MS-7435-0A Block Diagram

MICRO-STAR INT'L CO., LTD.			
Title History			
Size	Document Number		Rev
	MS-7435		0A
Date:	Thursday, October 23, 2008		Sheet 33 of 33

X1 LANE mini PCIE

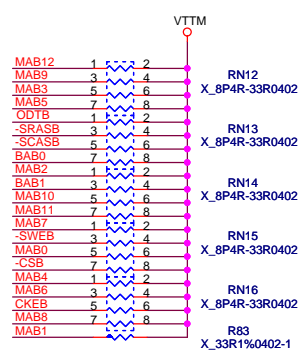
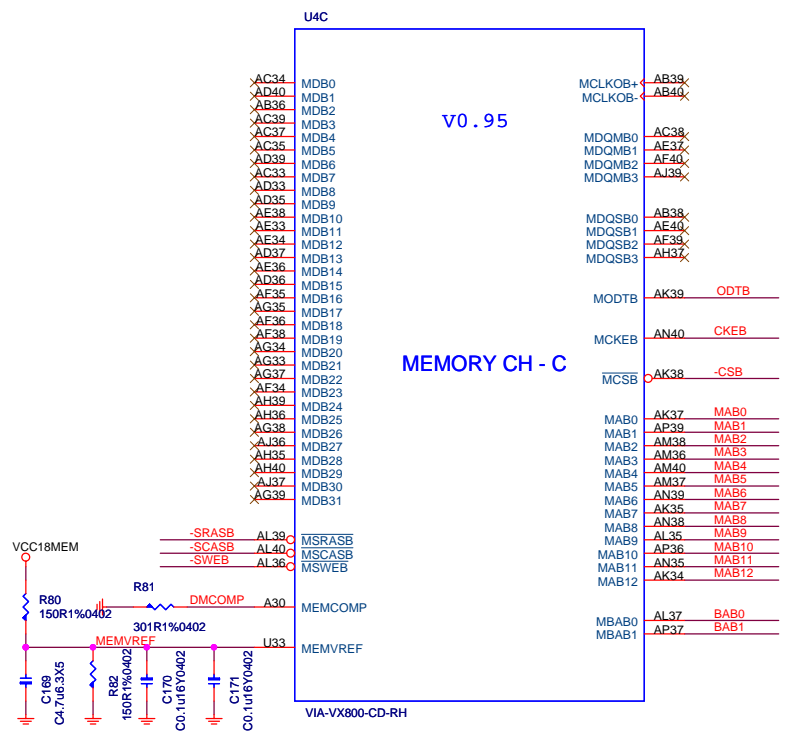
Schematic error , RN10 unmount ,RN11 mount ,
Remove R79,ODTA3 link to RN11---1007

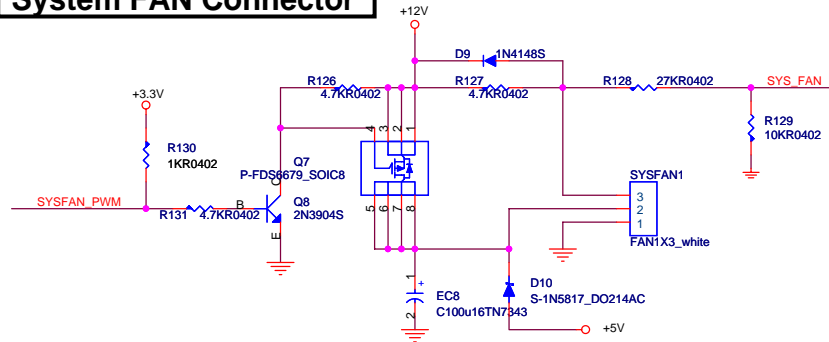
W83L786 Pin-17 & 18 are Open-Drain signals, they should be pulled up +3.3V

COM port

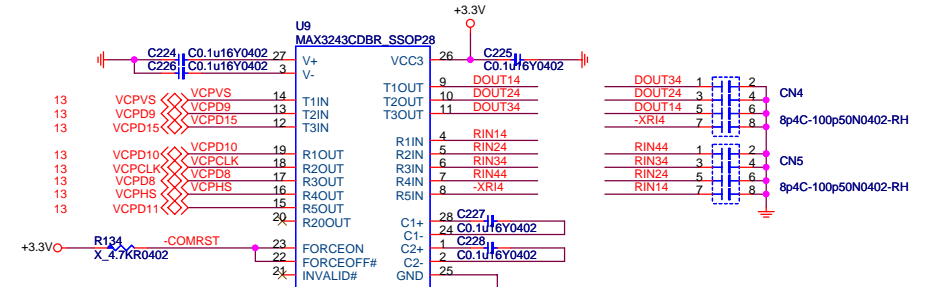
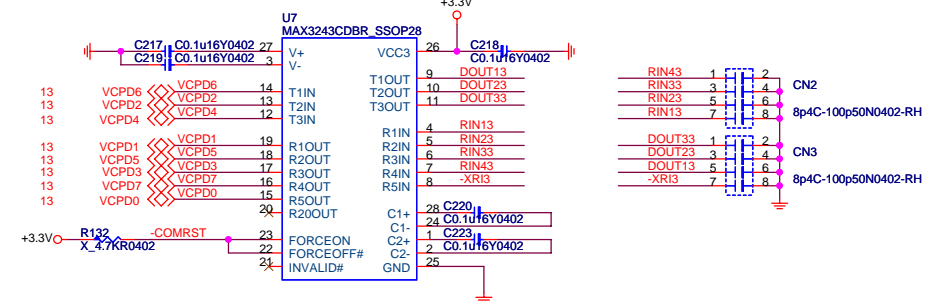
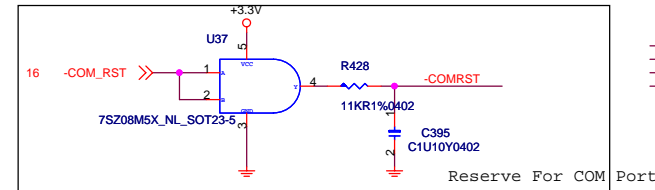
VIA Suggest:The VCP port and COM port is multiple function and it is recognize which function is after Reset.
=>So, we recommend use "Reserve circuit for COM port" by default.
Unmount R132,R134
Mount U37,R428,C395,R332

E-SATA JMB362

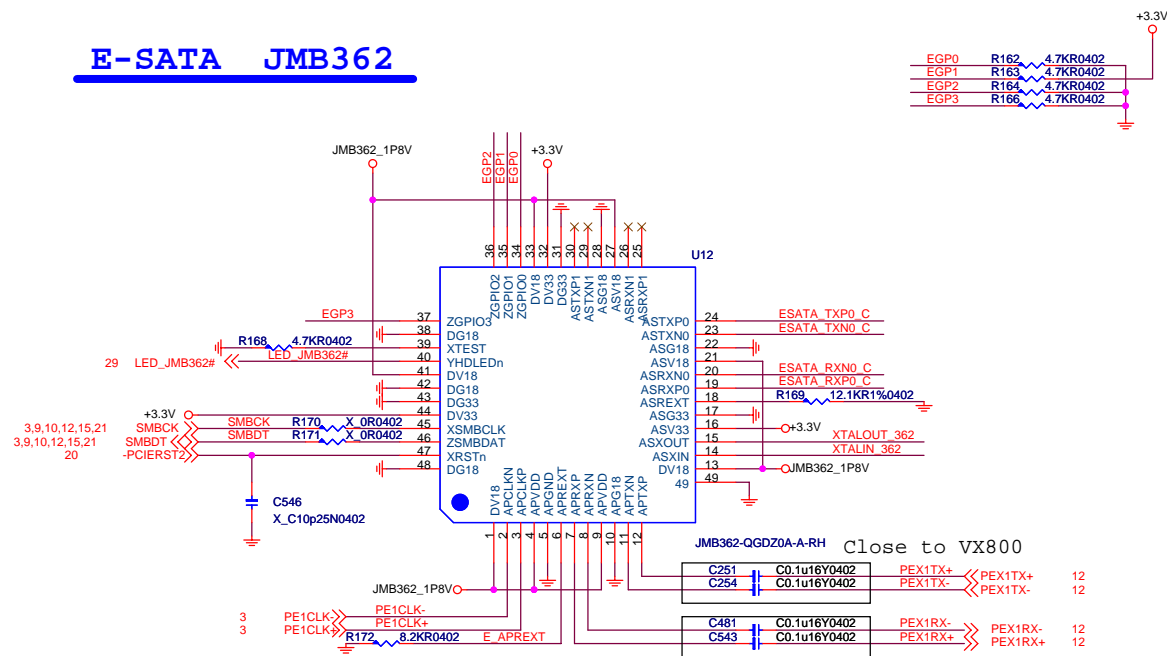
PS: The AC Cap should be place at Transition side of Device if your device is onboard.

Remove R173

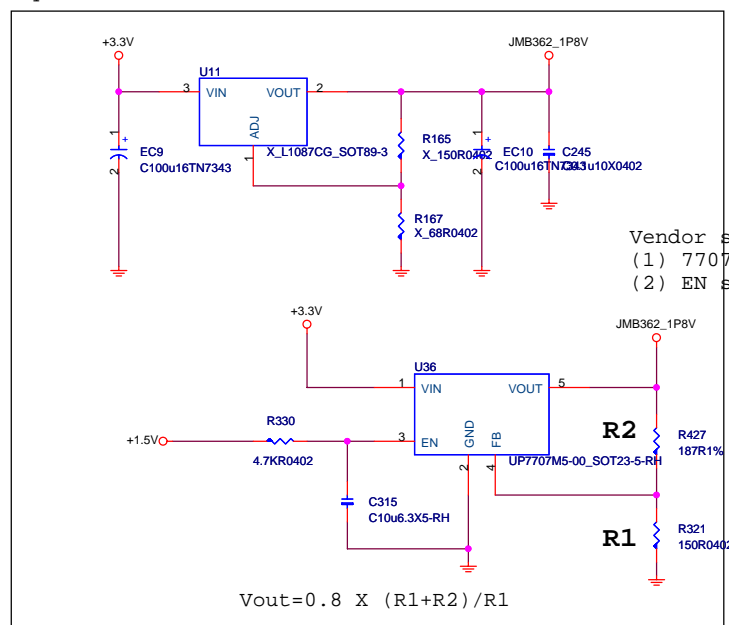
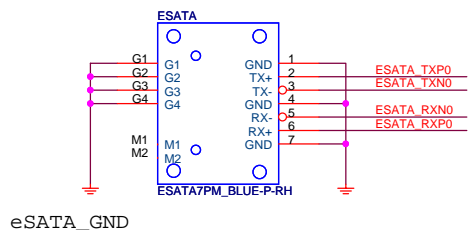
Vendor suggest, reserve:

- (1) 7707 and LDO co-layout
- (2) EN signal of 7707 is active after 40ms when 3.3V power ok

PHONE JACKER (HDA JACK)

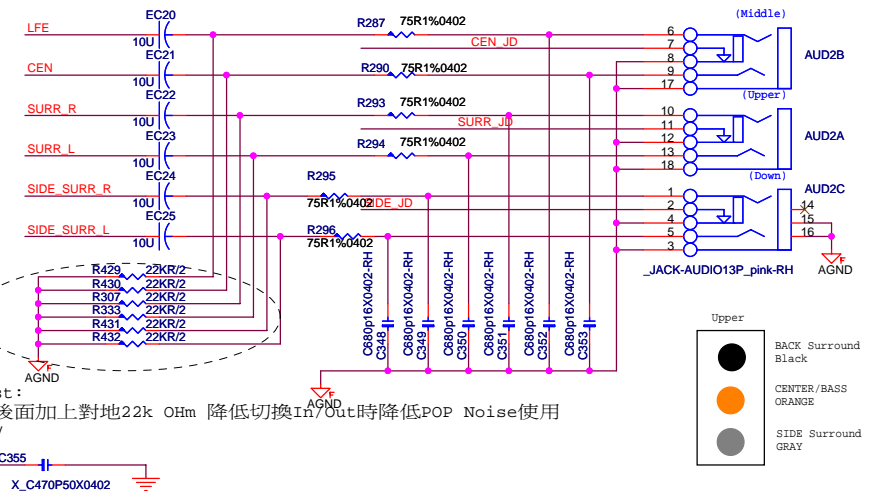
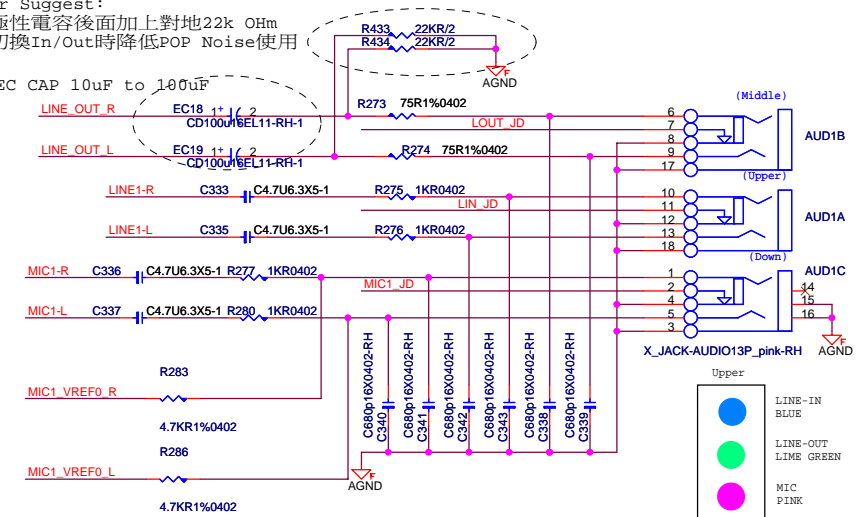
Vendor suggest:
Change R300 to 470hm, and near the front panel
Change to 1000pF, and near the front panel

Vendor Suggest:

在有極性電容後面加上對地22k OHm
降低切換In/Out時降低POP Noise使

Change Line Out EC CAP 10uF to 100uF

Vendor Suggest :

在有極性電容後面加上對地22k OHm 降低切換In/Out時降低POP Noise使用

CPU VCORE PWM CIRCUIT

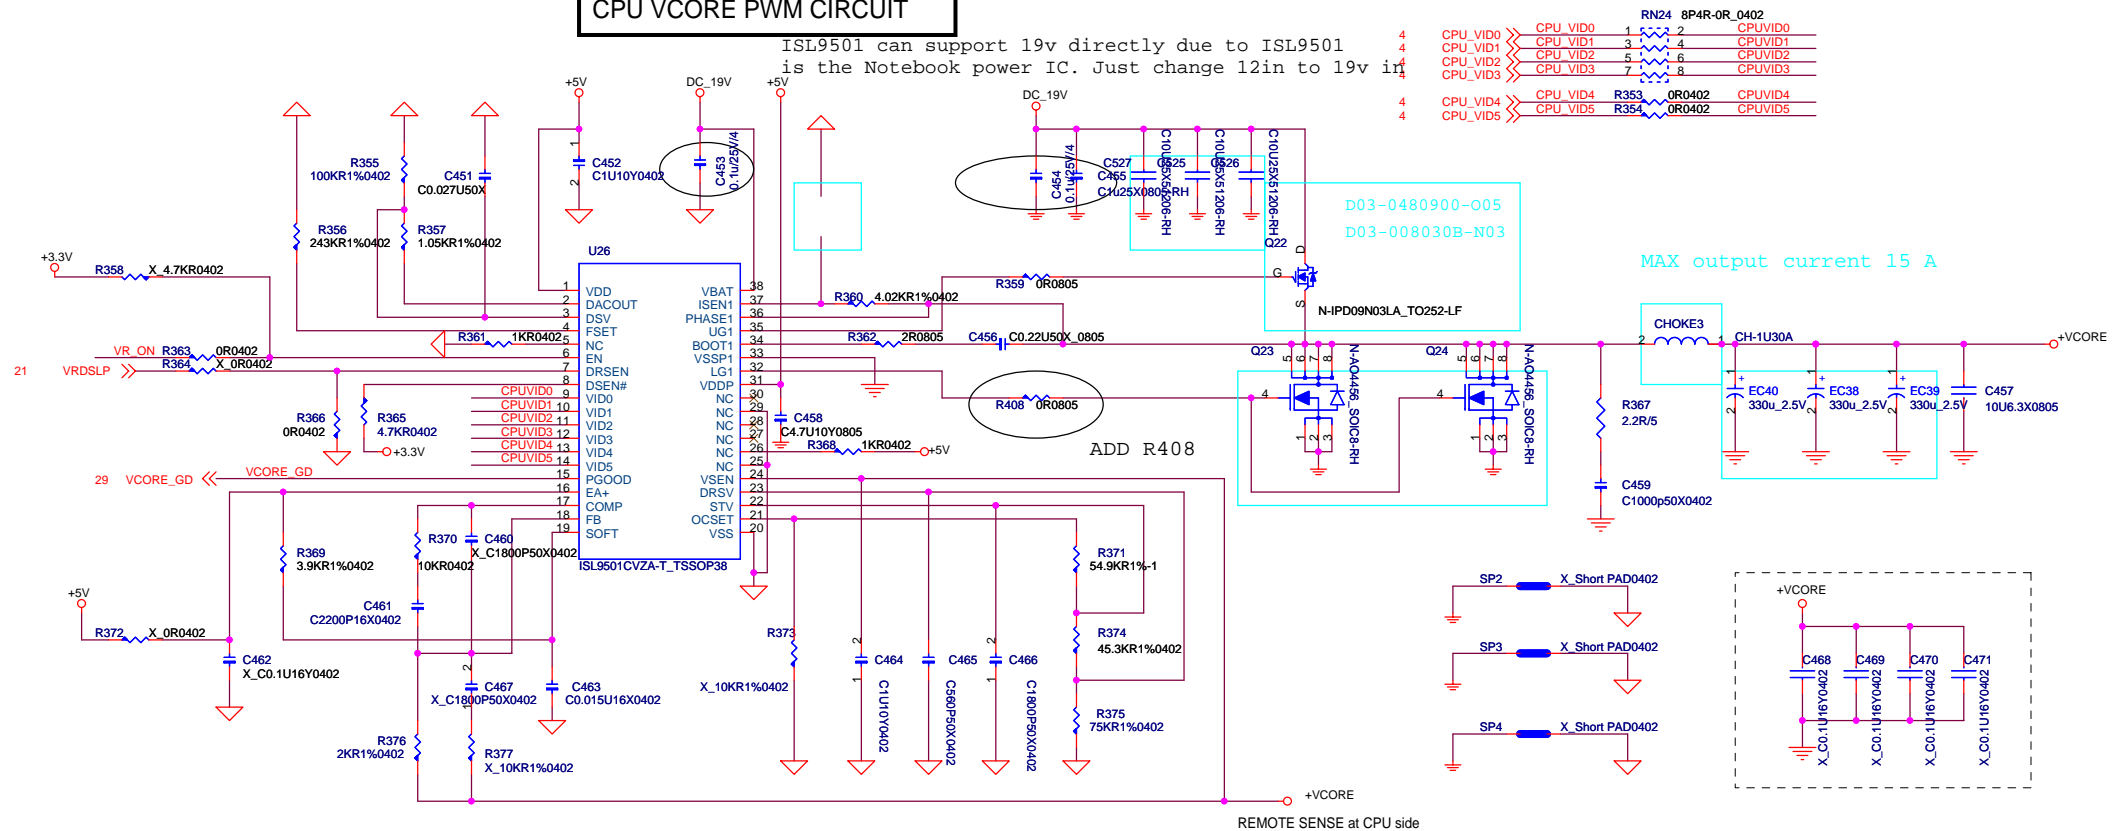
ISL9501 can support 19v directly due to ISL9501
is the Notebook power IC. Just change 12in to 19v in

Remove:CLK_EN to P3,-CPUSTP to P3&21,VCCSENSE to P5,-PSI to P4

VIA suggest : If your CPU PWM is not CLK enable function pin.
=>We recommend the CLK enable pin connect 10k ohm to +3.3V directly.
Unmount Q25 and C481,R379
